APPLICATION FOR AMENDMENT  
TO OPERATING LICENSE

Technical Specification  
Page Revisions

Indian Point Unit No. 3  
Docket No. 50-286  
Facility Operating License No. DPR-64

December, 1977

Figure 3.10-3

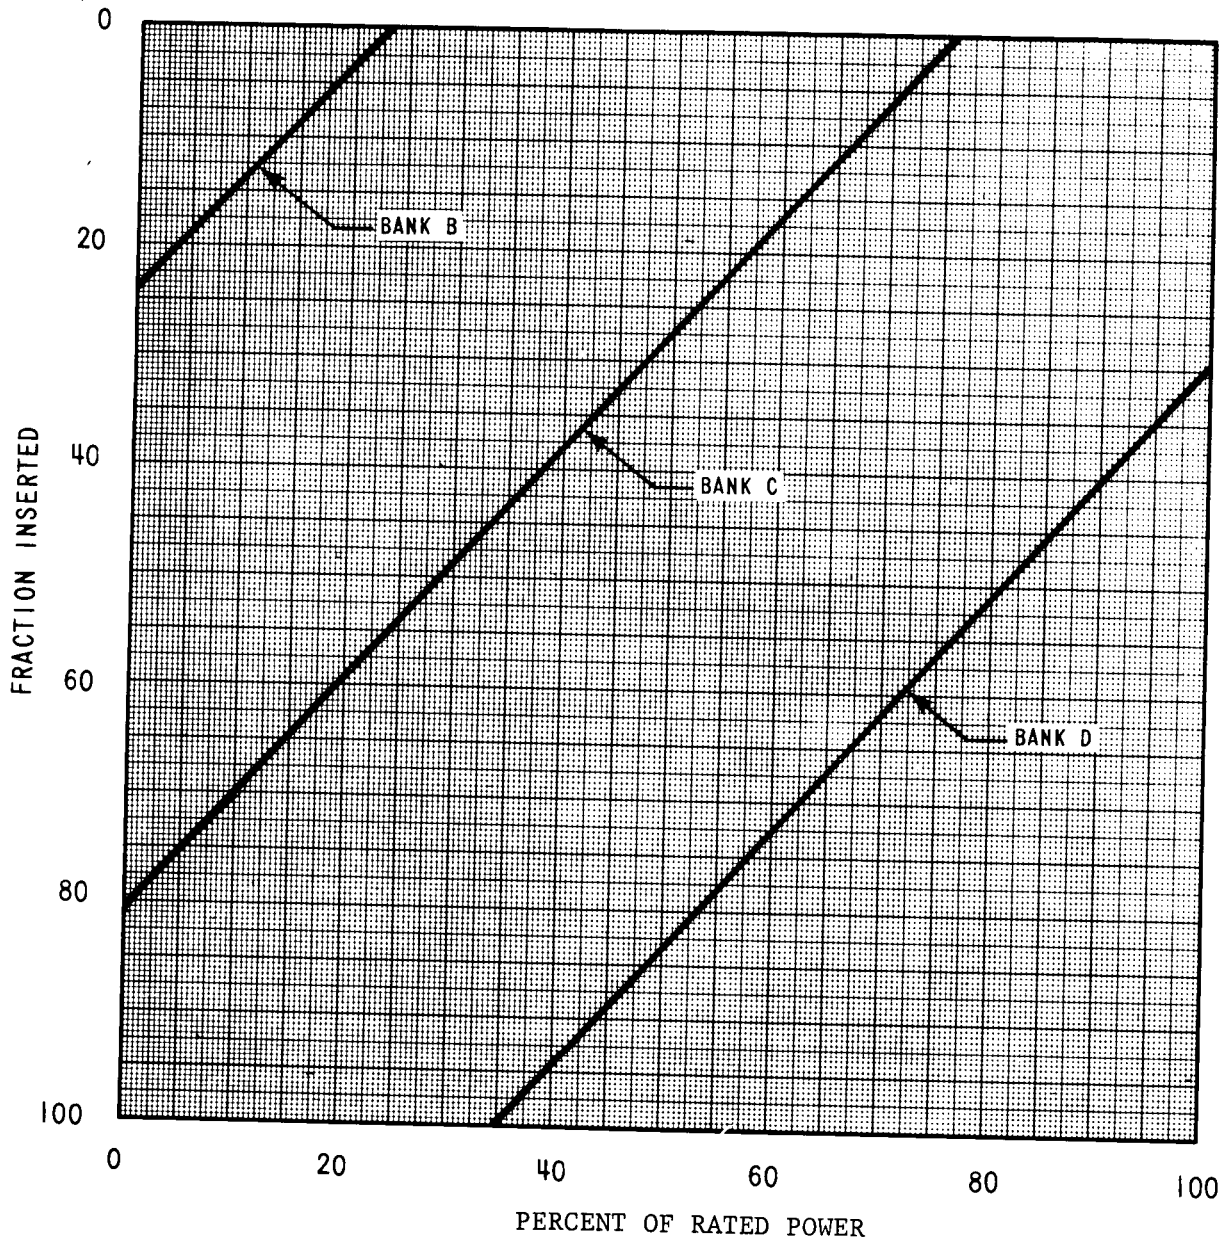
DELETED

Figure 3.10-4. Insertion Limits 100 Step Overlap  
Four Loop Operation

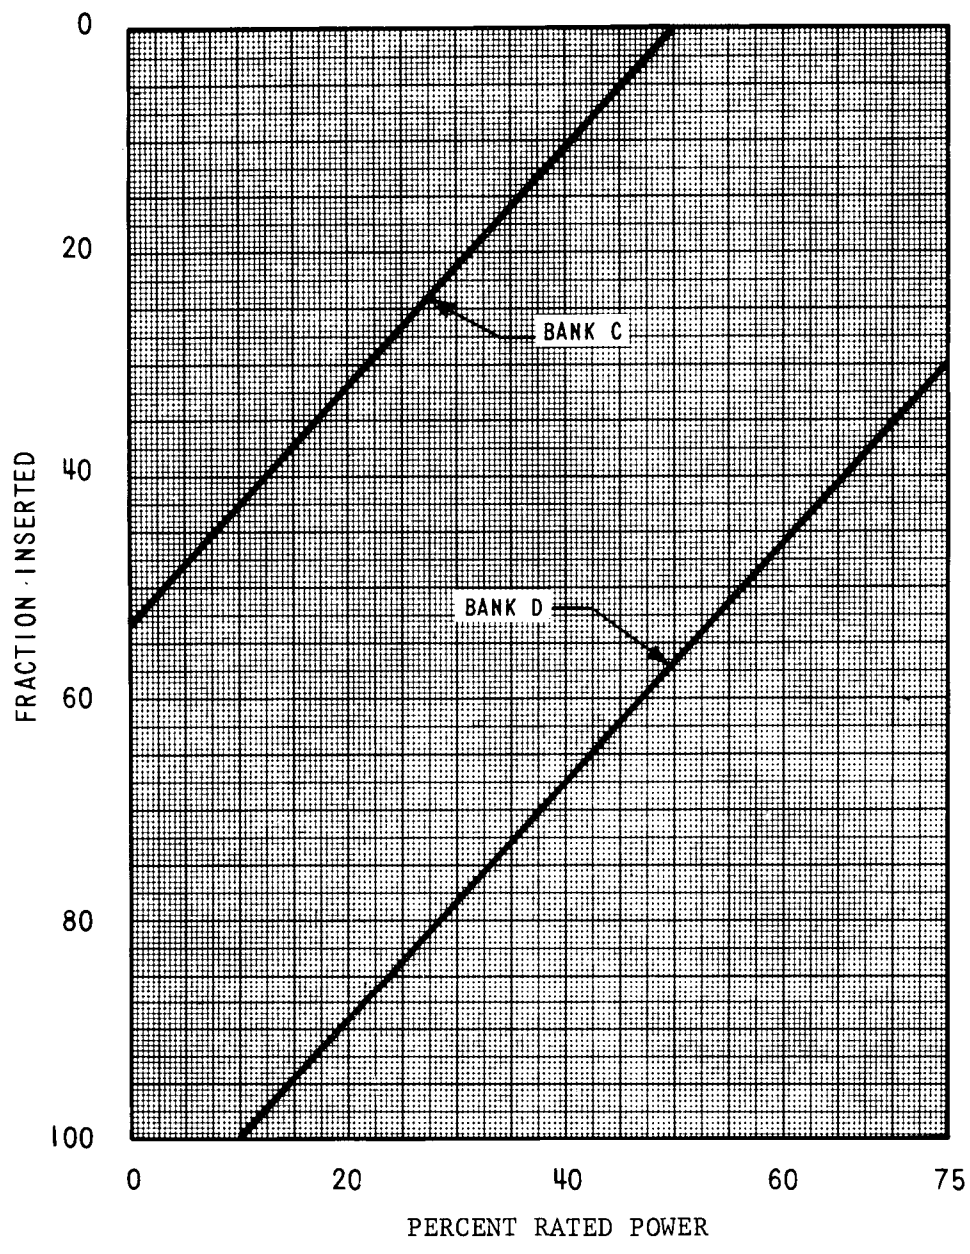
NOTE: BANK A IS FULLY WITHDRAWN AT ZERO POWER
